UNITED STATES PATENT AND TRADEMARK OFFICE

APPLICATION NO.	FILING DATE	FIRST NAMED INVENTOR	ATTORNEY DOCKET NO.	CONFIRMATION NO.
09/780,480	02/12/2001	Akira Senoo	Q62848	8117

Office Action Summary

DETAILED ACTION

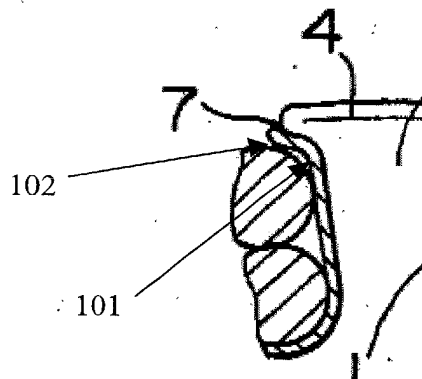
Honshima et al. clearly teaches the construction of an armature for an electric rotary machine, the armature comprising:

an armature core (2) provided with a plurality of slots (1) extending in an axial direction and disposed alongside each other in a circumferential direction;

an armature winding (3) inserted in the slots so as to be mounted on the armature core; and

an insulator (6) mounted in each of the slots wherein:

the insulator is disposed between an inner face of each slot and the armature winding (Figures 1, 2A, 2D, 4, 5A and 5B); and

first creases (101, added by the examiner) are formed on side portions of each insulator so as to extend in a lengthwise direction of the slot at a slot-opening end of the side portions, the first creases being formed by first bent parts for angling the slot-opening ends of the side portions so as to be apart from each other.

4. With regards to claim 11, Honshima et al. disclose second creases (102, added by the examiner) are formed on the side portions of each insulator so as to extend in a lengthwise direction of the slot at a location closer to the slot-opening end than the first creases, the second creases being formed by second bent parts for angling the slot-opening ends of the side portions toward each other.

5. With regards to claim 13, Honshima et al. disclose the side portion of each insulator expand in a circumferential direction at the bottom ends of the side portions of the insulator, thereby coming into close contact with inner faces of the slot toward the bottom thereof as shown in Figures 1, 2A, 2D, 4, 5A and 5B.
